Richmond Maintenance Facility Buildings

Addendum #2

BGS Project No: 3204

Date: 6/3/2022

C-1

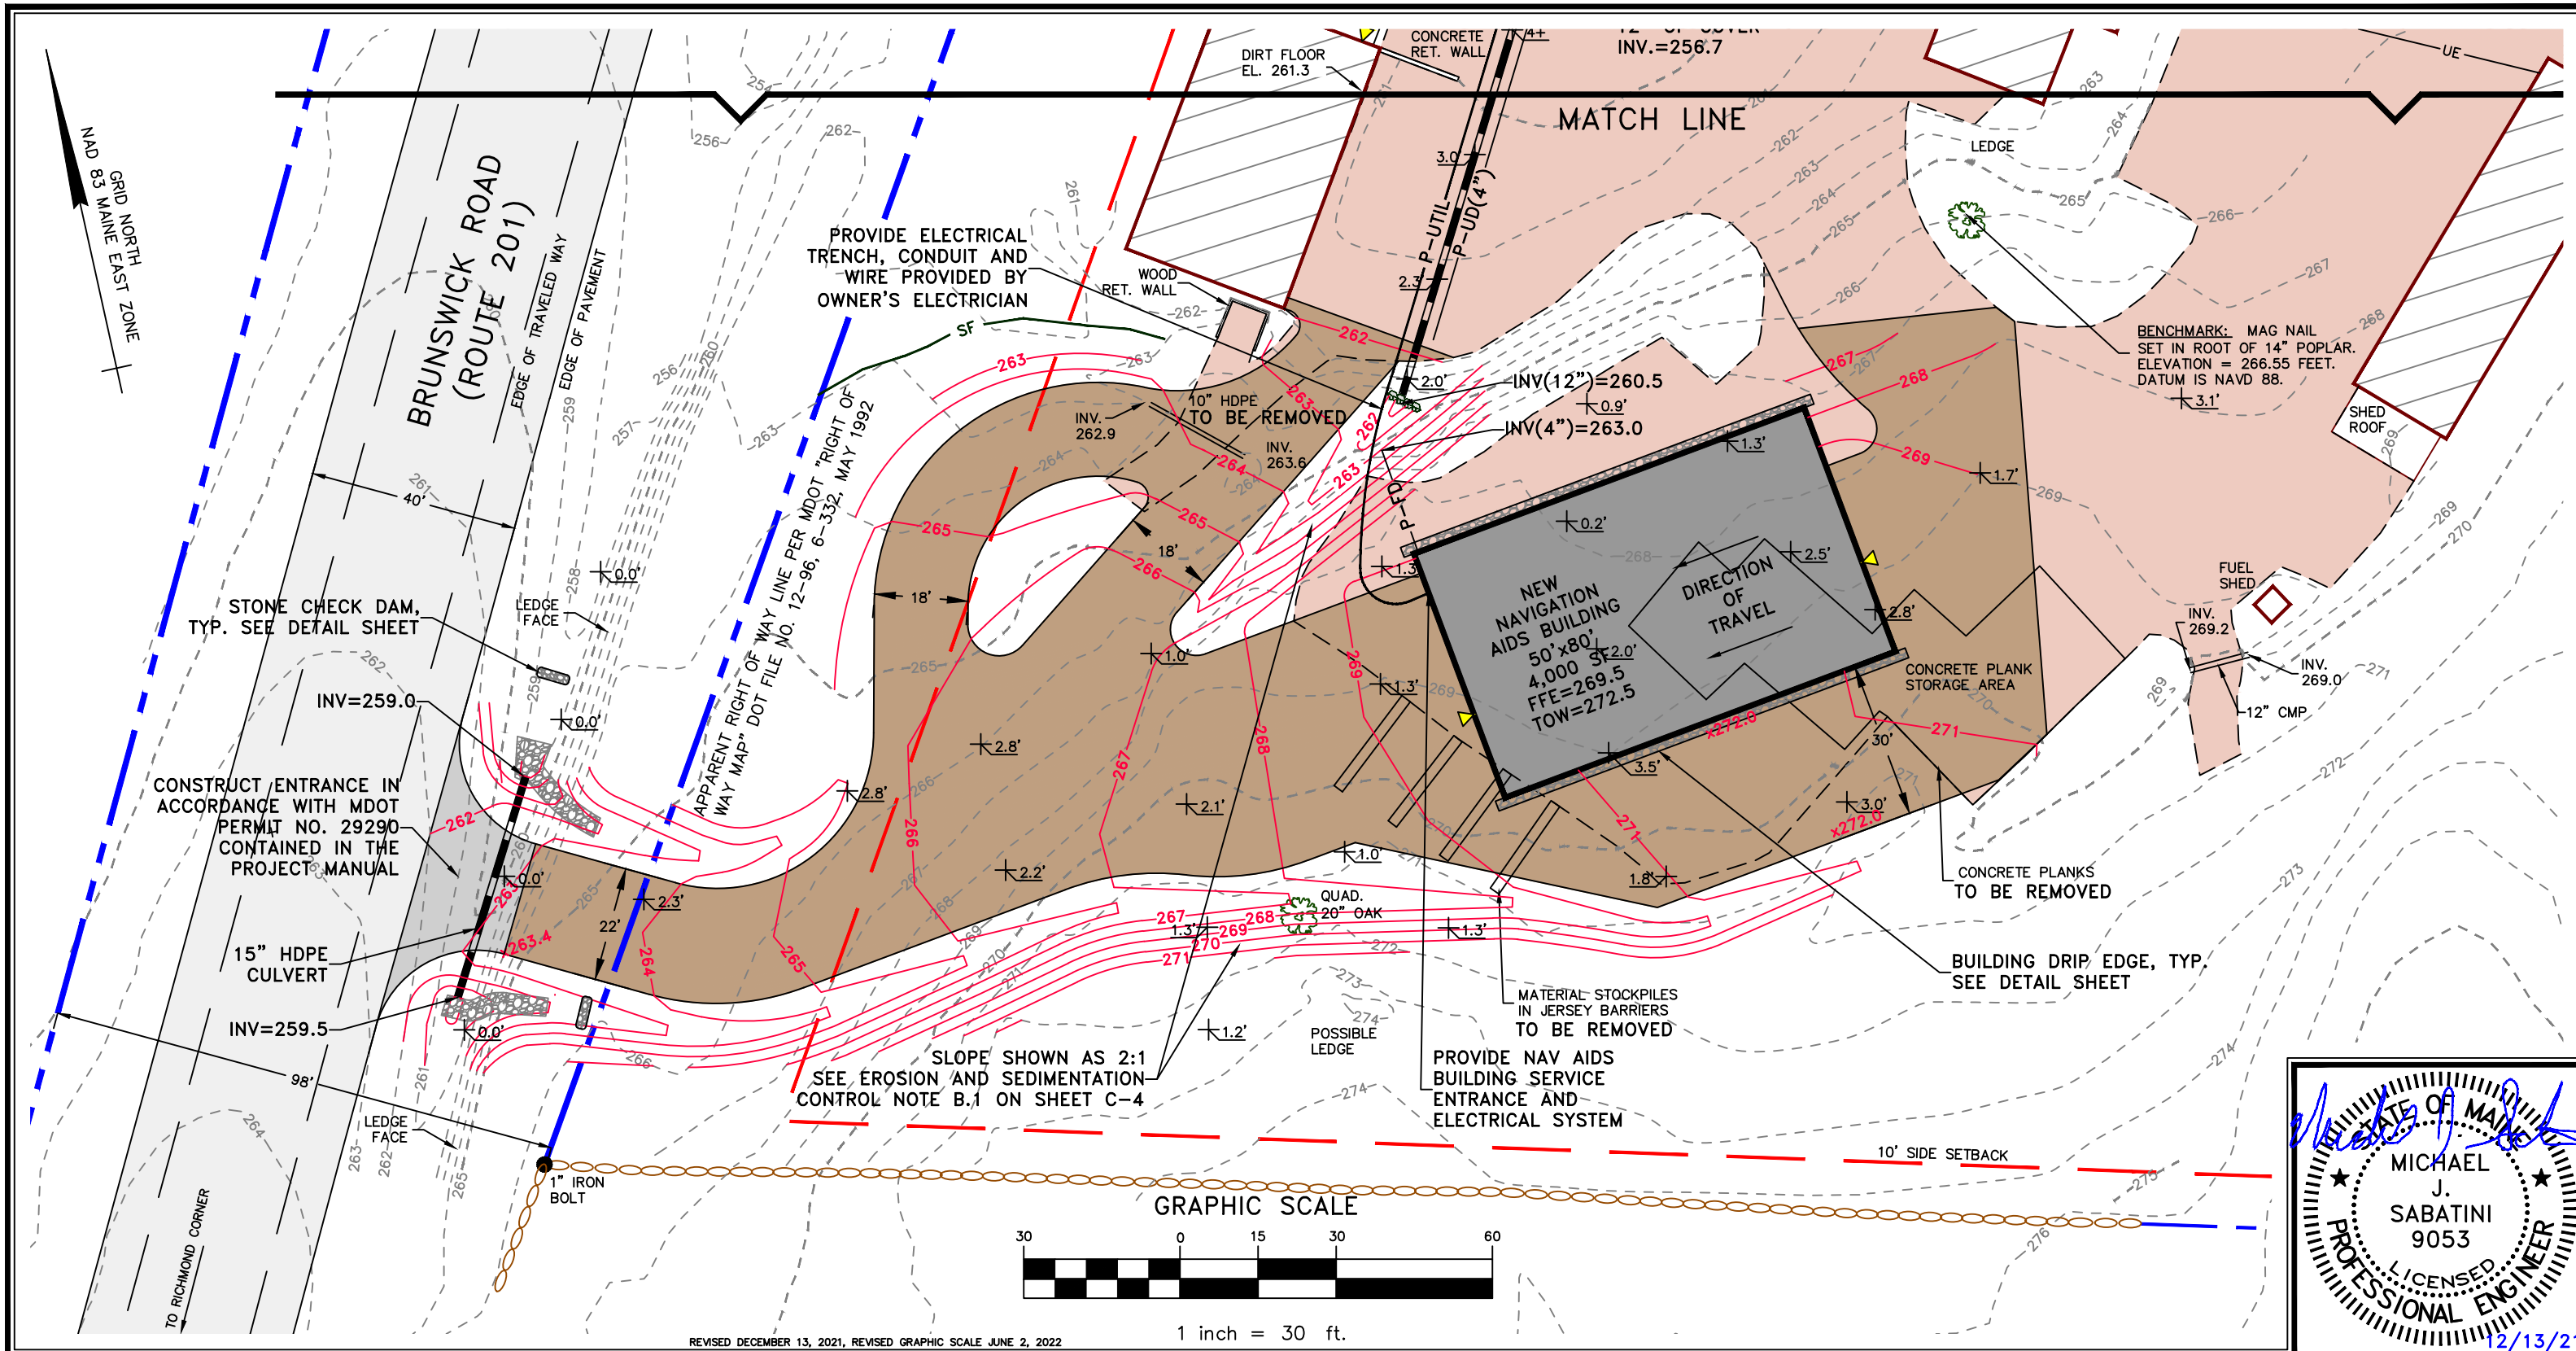
4. Plans Sheet C-1, C-2 and C-3 - The “Graphics Scale “ at the bottom of these sheets is out of scale. The scale noted in text below the scale bar is correct. Replacement plan sheets are attached to this

addendum. When printing a pdf, it is important to print at “no scale” or “actual size” or 100%. If done so, with the correct sheet size and orientation, it will print properly.
